**THE CITY OF THE VILLAGE OF DOUGLAS  
PLANNING COMMISSION  
THURSDAY, FEBRUARY 08, 2024 AT 7:00 PM  
86 W CENTER ST., DOUGLAS MI**

**RE:** 111 Wall St. Special Land Use – Residential Use of an Accessory Building

Thomas and Liana Allison, property owners, have submitted an application for Special Land Use review for the Residential Use of an Accessory Building, per Section. 26.31 of the City of the Village of Douglas Zoning Ordinance on a parcel of land described as Parcel No. 59-551-005-00, located at 111 Wall Street in the R-3, Neighborhood Conservation District. The parcel is also described as lot 5 of Spencer's Addition plat. The subject parcel is generally located on the south side of an unimproved section of the west end of Wall Street, just west of the Wall Street / Union Street intersection.

Site Plan

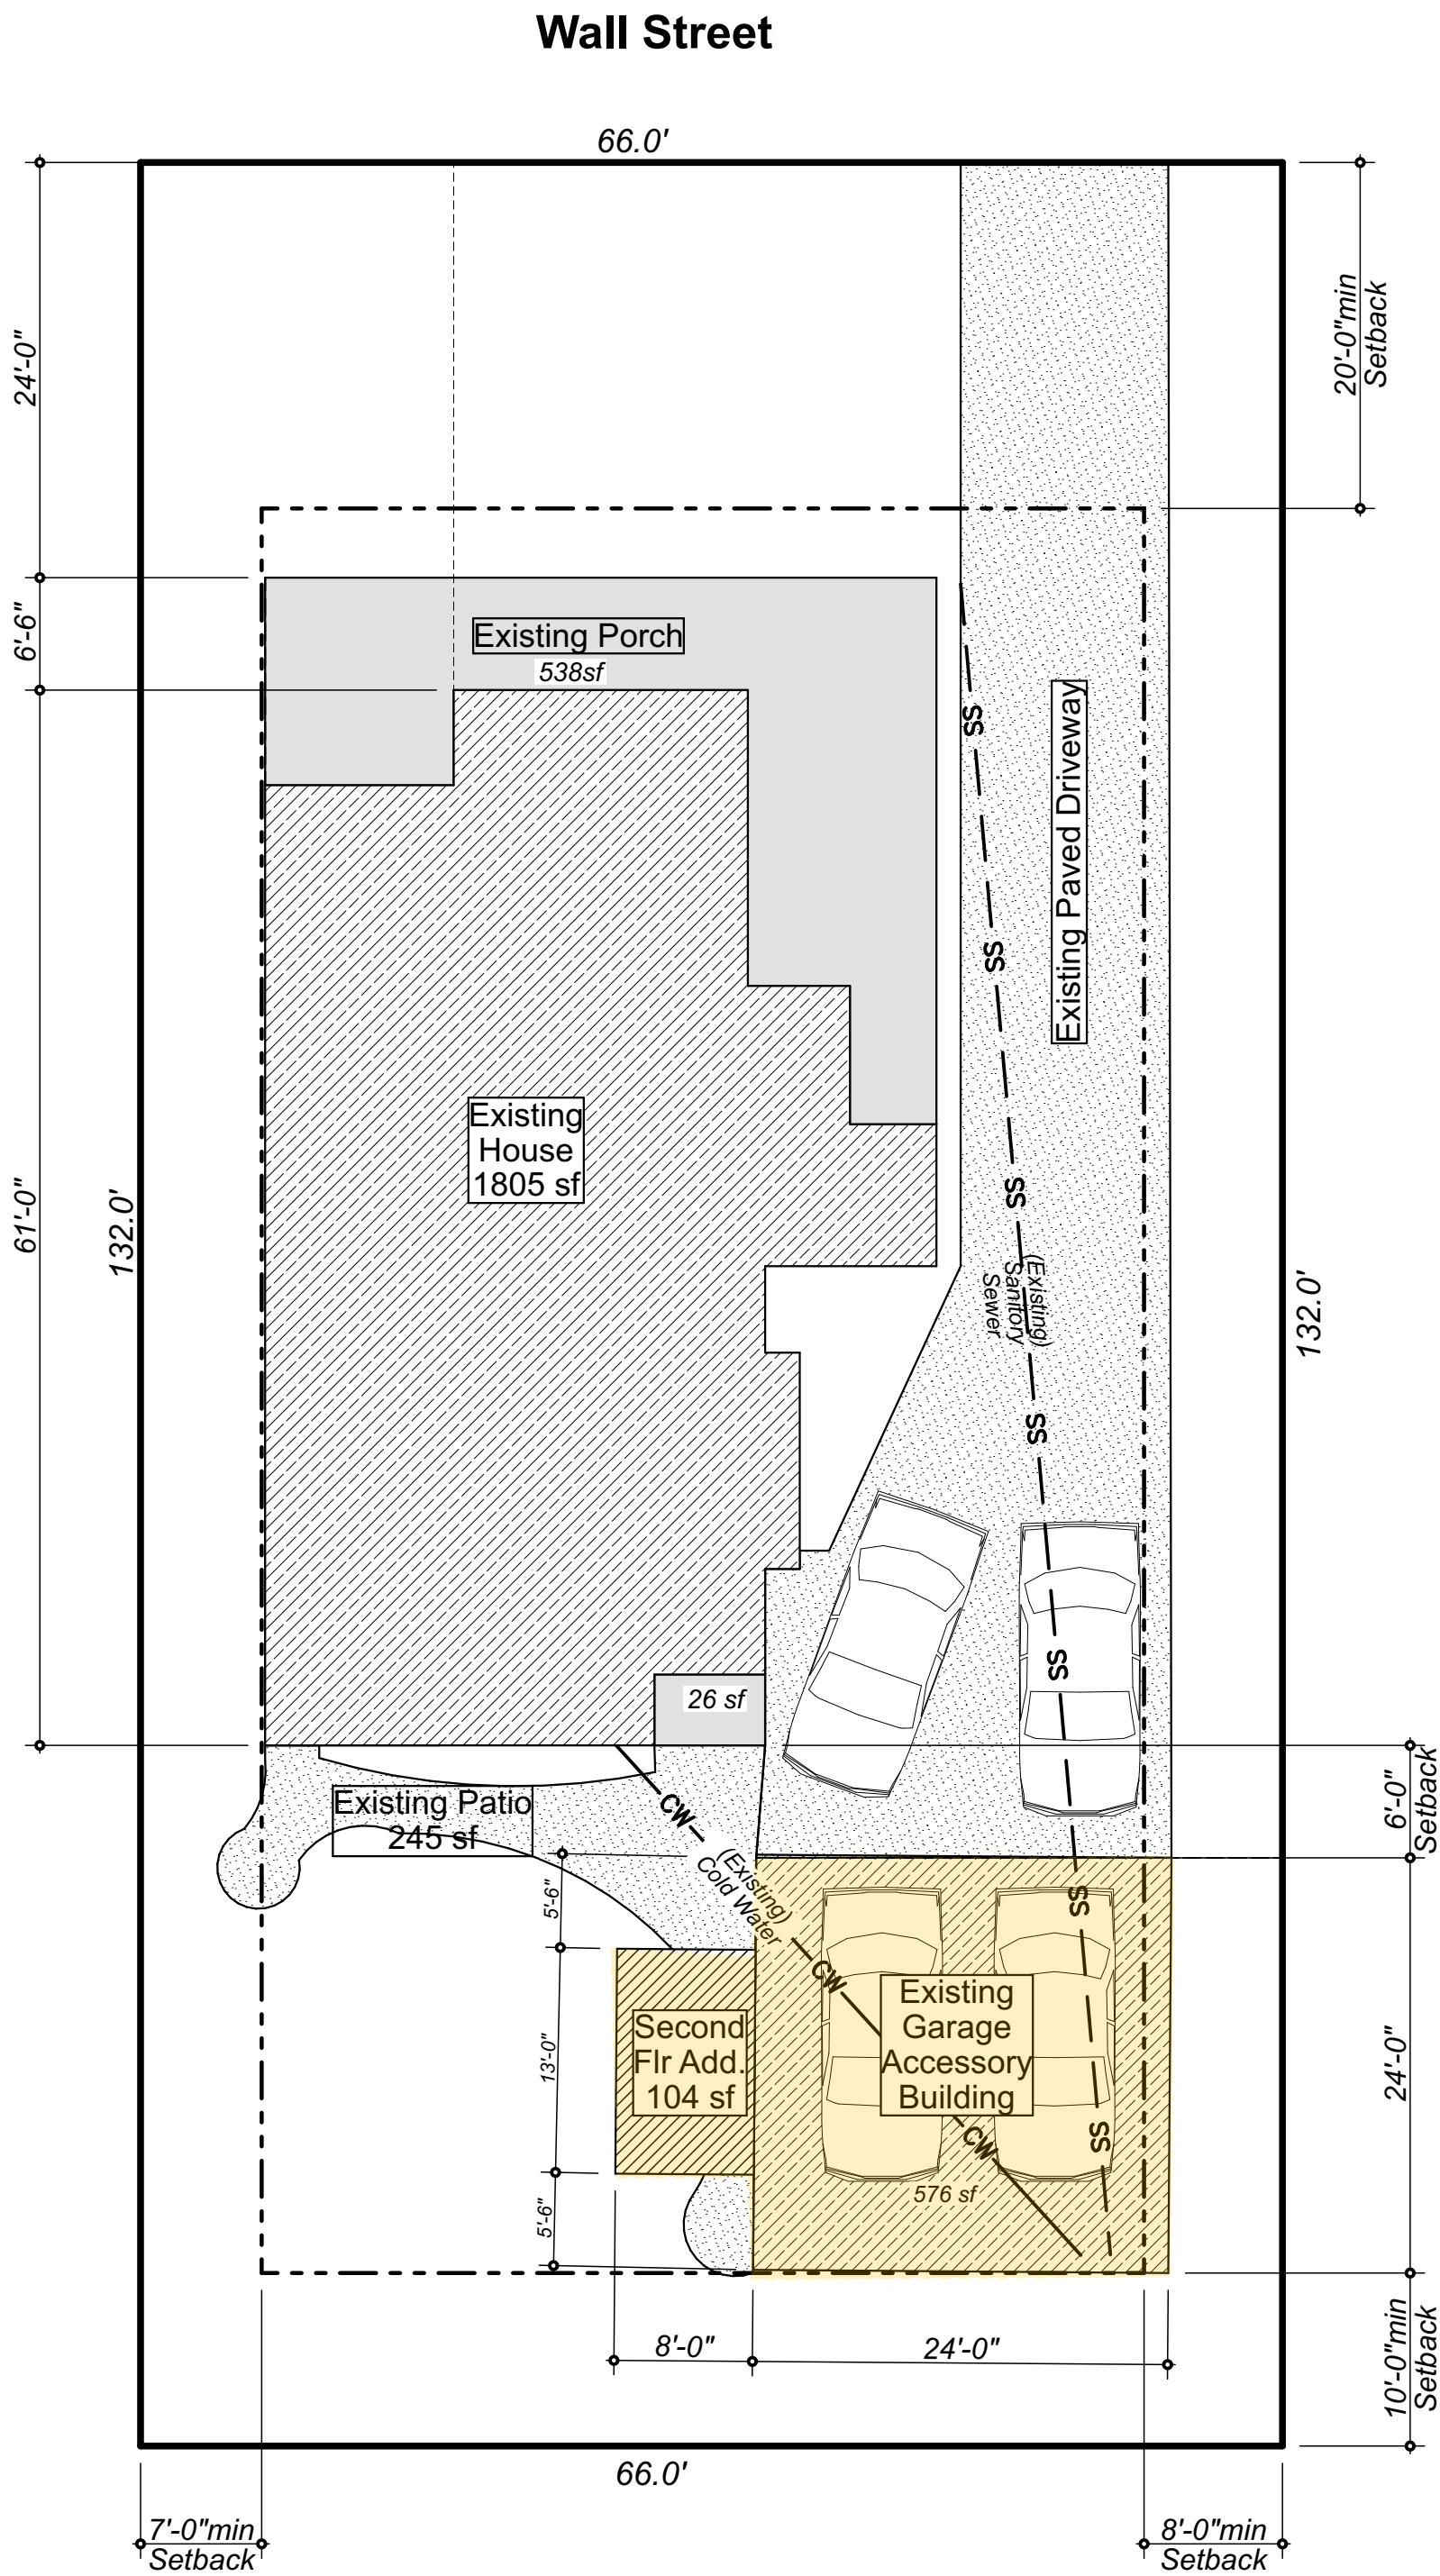
**Comment:** The principal and accessory structures meet the setback requirements, lot coverage and other lot requirements in Sec 3.12. This is noted on the site plan. This requirement is met.

**Comment:** The proposed residential area is planned to connect to utilities for water and sanitary sewer. This is shown on the site plan. This requirement is met.

**Comment:** The Planning Commission may find that this is met. The additional off-street parking spaces are shown on the site plan.
